**Subject: TCEQ Dam Safety Inspection for:
Inventory No. TX07227 - Oak Hollow Dam
Smith County**

DAM SAFETY INSPECTION REPORT

DAM: Oak Hollow Dam

Photo 3. View of a low spot (dashed lines) along the left end of the dam looking left. Note that a foot path traversed the low spot, which leads from the shoreline to the downstream toe area.

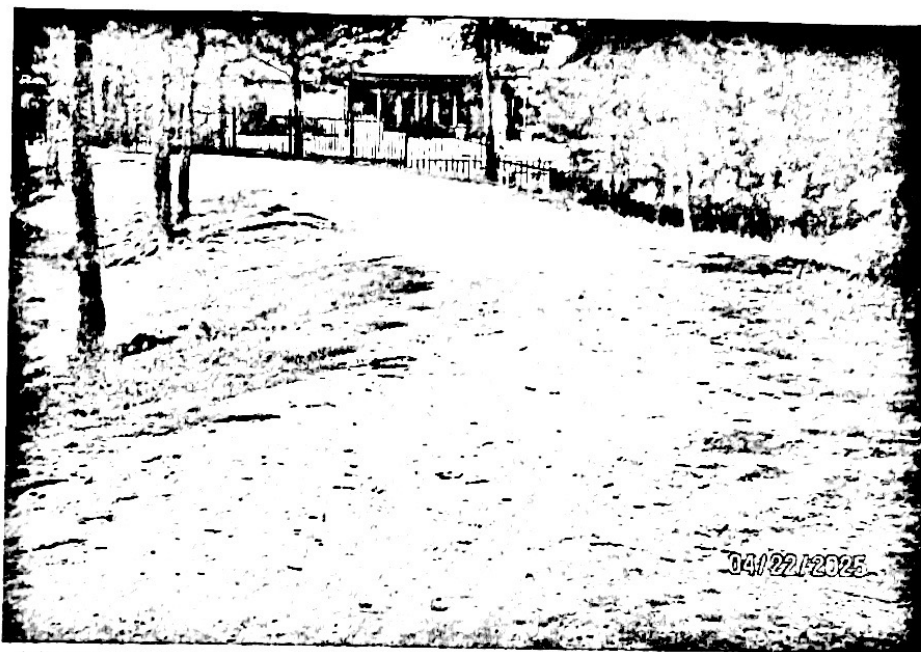
- The 10-foot-wide crest of the dam had no grass cover and littered with dry leaves and pine needles.
- Trees were observed along the upstream and downstream edges of the crest throughout the dam, and roots were observed traversing the crest.
- The previously noted low spot along the left end of the dam, was still present and appeared unchanged from the last inspection. The elevation difference with the overall crest was not measured at the time of this inspection.
- TCEQ records and previous report stated that the effective top of dam crest was at an elevation of 506 ft-msl; however, 2024 LiDAR data from the TxGIO website was utilized by the TCEQ. Based on LiDAR data, the effective top of dam crest elevation was estimated to be at an elevation of 497.7 ft-msl.
- The crest was found to be in fair condition.

6. Low spot on the crest near the left end of the dam should be further investigated by the owner's PE. Re-establish a uniform crest elevation over the crest length by filling in low areas using proper construction techniques. Keeping an aligned and leveled crest will also allow for proper drainage of water from the crest to the inside slope and prevent standing water along the crest.

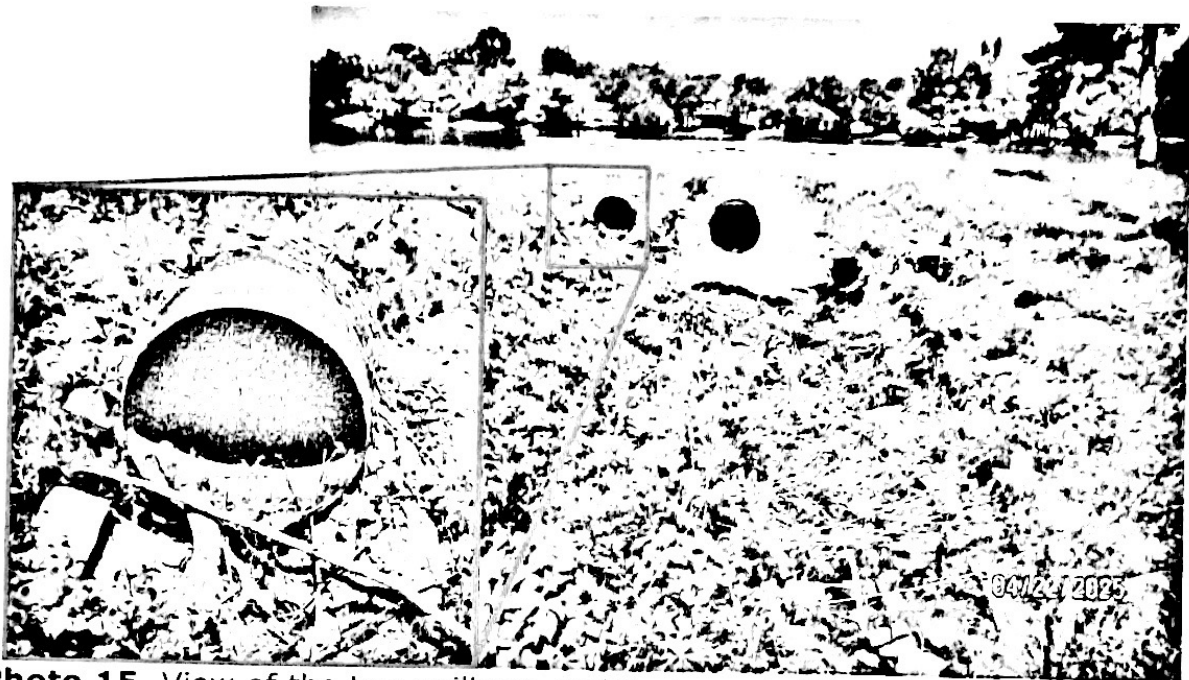
- The spillway outlet pipes were generally clear, with some minor vegetative debris on the right outlet pipe.
- The surrounding concrete headwall structure was deteriorated and undermined, primarily along the left side by about 3-feet deep.

Photo 15. View of the two spillway outlet pipes at different elevations and a deteriorated headwall structure, looking upstream. Note the accumulated debris at the end of the right outlet steel pipe. Also note that the pipe adjacent to the steel pipe is a High-Density Polyethylene (HDPE) pipe. The direction of flow is noted by the arrows.

Photo 16. View of an undermined area along the left side of the concrete headwall structure. The area was probed at about 3-feet deep.

4. Undermining erosion beneath the concrete headwall outlet structure and erosion damage to the left of the spillway outlet pipes should be repaired. The affected area should be backfilled with properly compacted non-dispersive clay, re-graded, and re-establish a vegetative cover.

Photo 19. View of the low flow valve stem and operator wheel partially covered by dry cover of pine needles and leaves.

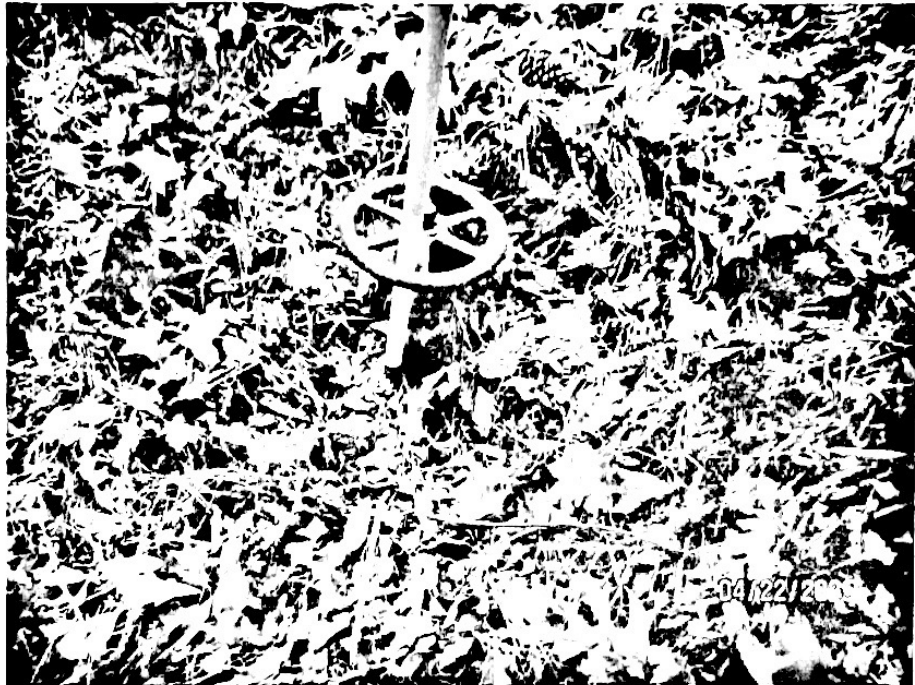
- The low flow system is located near the center of the dam. The inlet pipe was not observed, and it is most likely in the reservoir; however, the outlet pipe was observed along the downstream toe.
- The valve stem with operator was located mid-way up the downstream slope in-line with the pipe.
- The valve stem and operator wheel were partially covered by dry ground, pine needles, and leaves.
- Standing water was observed in a small pool just downstream of the low flow outlet pipe. The pool was about 2-feet deep, and it was not determined if the standing water was being fed by the leaking low flow or simply from runoff. Note this was a different pooled area than the one mentioned in the 2019 report.
- The operational condition of the low flow system is unknown.

9. The low flow system should be further investigated by your PE. If the low flow is ever inspected and functional then it should be exercised at least on an annual basis to ensure it is in good working order and capable of lowering/draining the reservoir should an emergency situation ever warrant such. If the gate has not been operated for a substantial period of time, it is recommended that your PE devise a plan to assess the functionality and ensure that the gate does not get stuck open and unduly drain the reservoir. The wheel for the gate valve should be locked in place for security measures if the outlet is to be used as described above.
